UNITED STATES PATENT AND TRADEMARK OFFICE

APPLICATION NO.	FILING DATE	FIRST NAMED INVENTOR	ATTORNEY DOCKET NO.	CONFIRMATION NO.
10/552,971	10/18/2006	William R. Tonti	BUR920020076US2	6772

Office Action Summary	Application No. 10/552,971	Applicant(s) TONTI ET AL.	
	Examiner ALEXANDER SOFOCLEOUS	Art Unit 2824

DETAILED ACTION

Fig 5 a Old Figure 5a

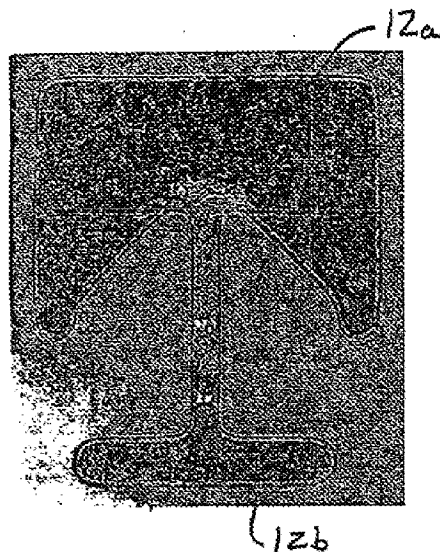
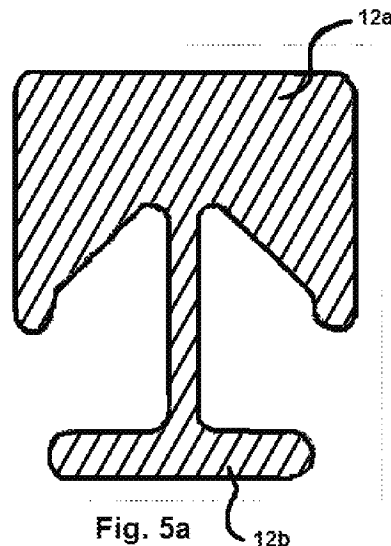
5. Figures 2, 3, 4a, 4b, 4c, 5a, and 5b appear to be photographs (?) or scanned images (?) and may not be as clear as was intended. It is noted that the Figures found in the Provisional application (60/462,568) are much clearer.

It is suggested to review the quality of these present Figures as they appear on Public Pair (or by in Patent Application Publication 2007/0242548). For example, Figure 5b may benefit from an alternate presentation (perhaps a computer-drawn model may be more appealing? or perhaps resubmitting clean versions of these Figures from provisional application). Applicant is invited to make any necessary adjustments to presentation of these Figures. One potential quick computer-drawn presentation for Fig. 5a is provided on the next page of

Fig. 5a
Examiner Proposed Correction

Corrected drawing sheets in compliance with 37 CFR 1.121(d) are required in reply to the Office action to avoid abandonment of the application. Any amended replacement drawing sheet should include all of the figures appearing on the immediate prior version of the sheet, even if only one figure is being amended. The figure or figure number of an amended drawing should not be labeled as "amended." If a drawing figure is to be canceled, the appropriate figure must be removed from the replacement sheet, and where necessary, the remaining figures must be renumbered and appropriate changes made to the brief description of the several views of the drawings for consistency. Additional replacement sheets may be necessary to show the renumbering of the remaining figures. Each drawing sheet submitted after the filing date of an application must be labeled in the top margin as either "Replacement Sheet" or "New Sheet" pursuant to 37 CFR 1.121(d). If the changes are not accepted by the examiner,

EXAMINER MARK-UP
NARAYAN et al. FIG. 3

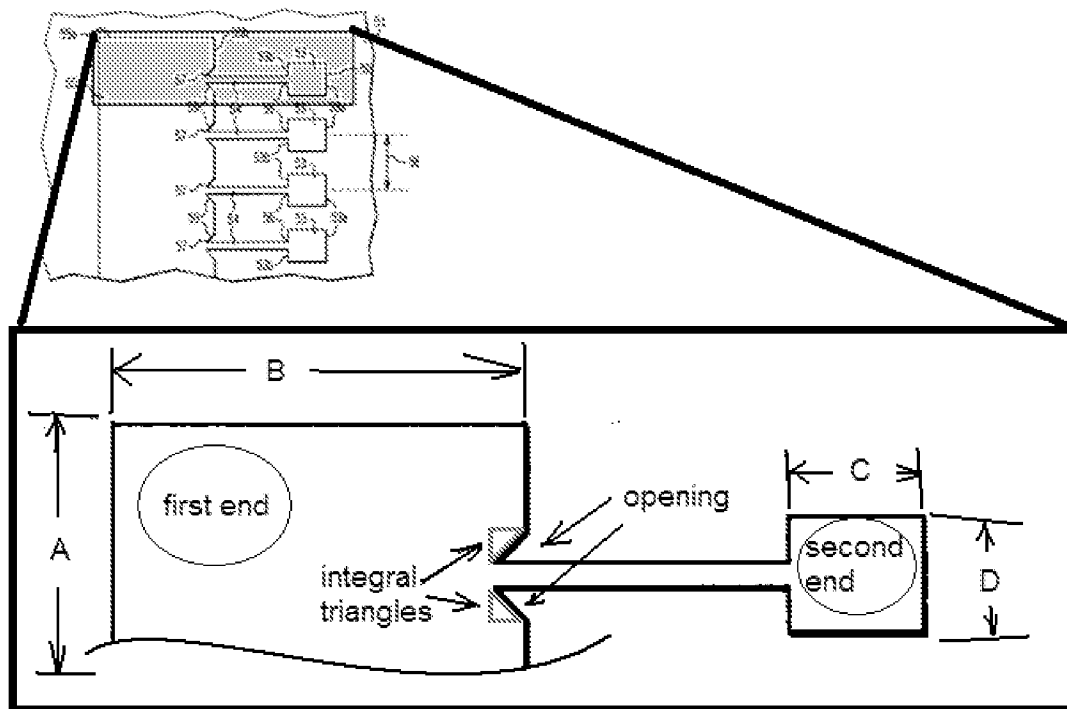
Regarding independent claim 1, Narayan et al. teach a programmable device (see Fig. 3), comprising:

- a substrate (Fig. 3: 51; see e.g., Fig. 8: 41);
- an insulator (see e.g., Fig. 8: 91) on said substrate (Fig. 8: 41);
- a metallic material (see e.g., Fig. 8: 43) on said insulator (Fig. 8: 91), said metallic material being physically migratable responsive to an electrical current flowable through said metallic material (see column 12, lines 23-28; while the specific term “migratable” is not used in this reference, when the fuse is blown in response to an appropriate current, the fuse material will necessarily move);
- wherein said first end (see Examiner Mark-up Fig. 3: first end) of the metallic material is substantially wider (see Examiner Mark-up Fig 3: either of

widths A or B) than said second end (see Examiner Mark-up Fig. 3: second end with respect to either of widths C or D) and comprising a plurality of integral triangular-shaped portions (see Examiner Mark-up Fig. 3: integral triangles; while specific term "integral triangles" is not used in this reference, the term is presently considered met by triangular shapes included in, *or integrated* into, the fuse structure, which the mark -up shows) forming openings (see Examiner Mark-up Fig. 3: opening) which face generally toward said second end (see Examiner Mark-up Fig. 3: second end).

Regarding dependent claim 7, Narayan et al. and Marshall et al., as combined, further teach said second end (see Examiner Mark-up Fig. 3: second end) comprises an oblong-shaped portion (see Examiner Mark-up Fig. 3: dimension C appears greater than dimension D).

Regarding dependent claim 14, Narayan et al. and Marshall et al., as combined, further teach said central portion (Narayan Fig. 3: 54; see Marshall et al. Fig. 5A: 203) and said second end (see Examiner Mark-up Fig. 3: second end) form a T-shaped member (the center portion and the second end, as taught by the combination, forms a substantial T-shape).
